## TECHNICAL SERVICE BULLETIN

### Front Window Glass Jumps/Chatters During Up/Down Travel

**19-2382**  
17 December 2019

| Ford<br>2016-2017 Explorer |

Figure 1

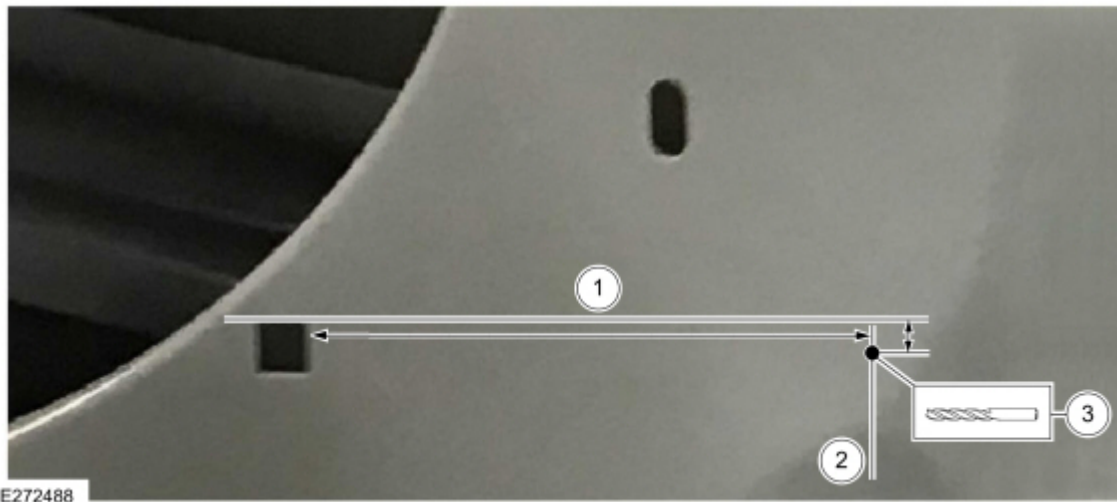
2. Remove the front door glass. Refer to WSM, Section 501-11.
3. Remove the front door glass top run. Refer to WSM, Section 501-11.
4. Disconnect and remove the front door wiring harness.
5. Locate and drill the new regulator hole.
  - (1). Place a ruler horizontally along the top edge of square hole shown in Figure 1 draw a line 65 mm (2.5 inch) long. Refer to Figure 2, Callout 1. (Figures 1-2)
  - (2). Measure 46 mm (1.8 inch) from the door latch side edge of the square hole and place a vertical mark at the intersection of the horizontal line drawn in Step 5(1). (Figure 2, Callout 2)
  - (3). Measure down 2 mm (0.08 inch) from the horizontal line along the vertical line and place a mark. (Figure 2, Callout 3)
  - (4). Place a centering mark at the location marked in Step 5(3) using a hammer and center punch and drill a 9 mm (0.35 inch) diameter hole.

Figure 3

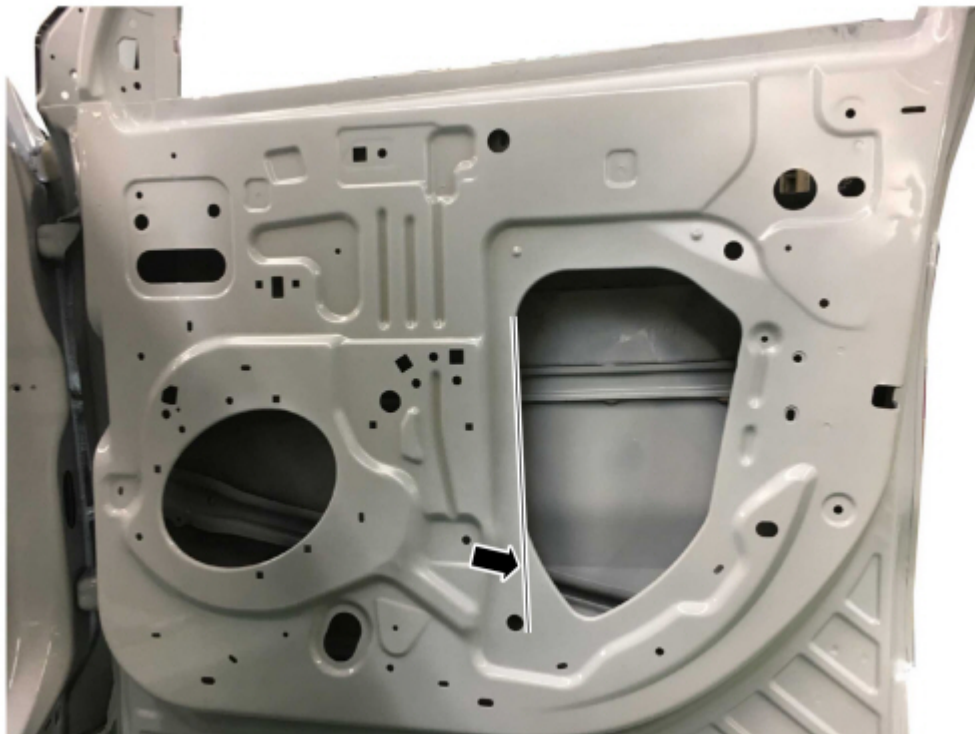
(1). Place a straight edge vertically along the edge of the large stamped regulator access opening in the door on the door hinge side of the opening and draw a line that extends to the bottom of the stamped opening. (Figure 3)

Figure 4

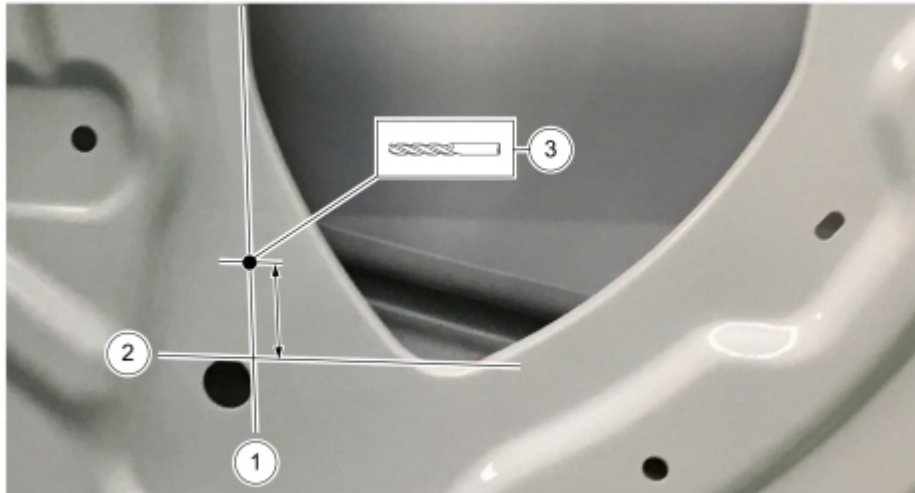
(2). Place the straight edge horizontally along the lowest point of the stamped opening and across the top of the round hole towards the door hinge side of the door and draw a line between the bottom of the stamped opening and the hole. (Figure 4, Callout 2)

(3). Measure up 32 mm (1.25 inch) from the horizontal line along the vertical line and place a centering mark using a center punch and hammer. (Figure 4)

(4). Drill a 6.5 mm (0.25 inch) diameter hole. (Figure 4, Callout 3)

Figure 5

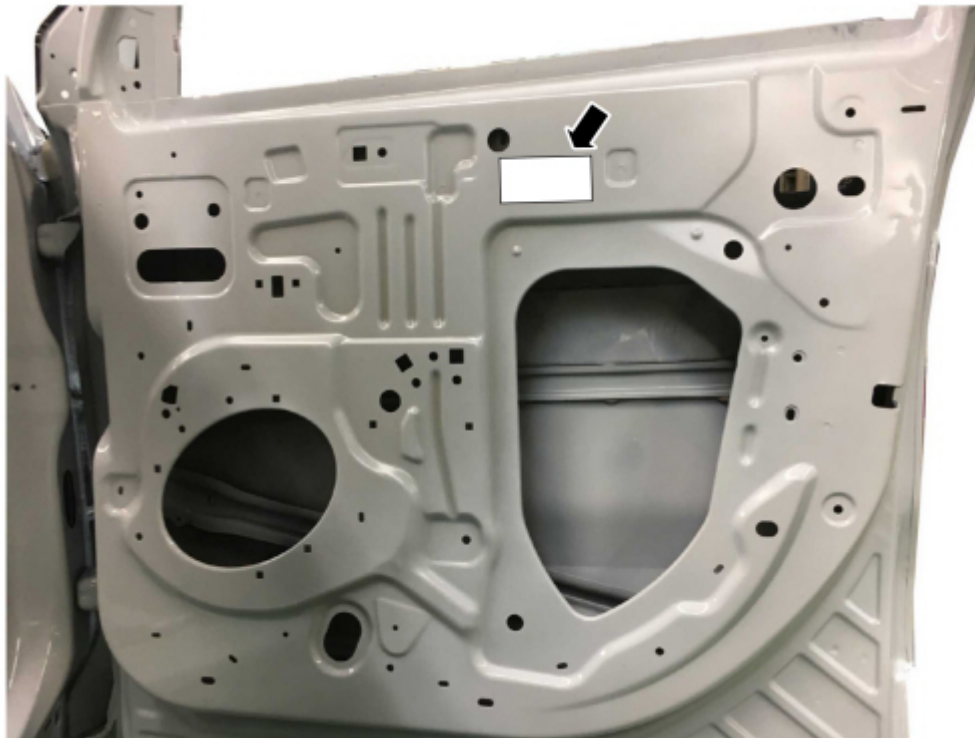
(2). Attach the information label to the door sheet metal above the window regulator access opening using clear packaging tape completely covering the label with tape. (Figure 5)
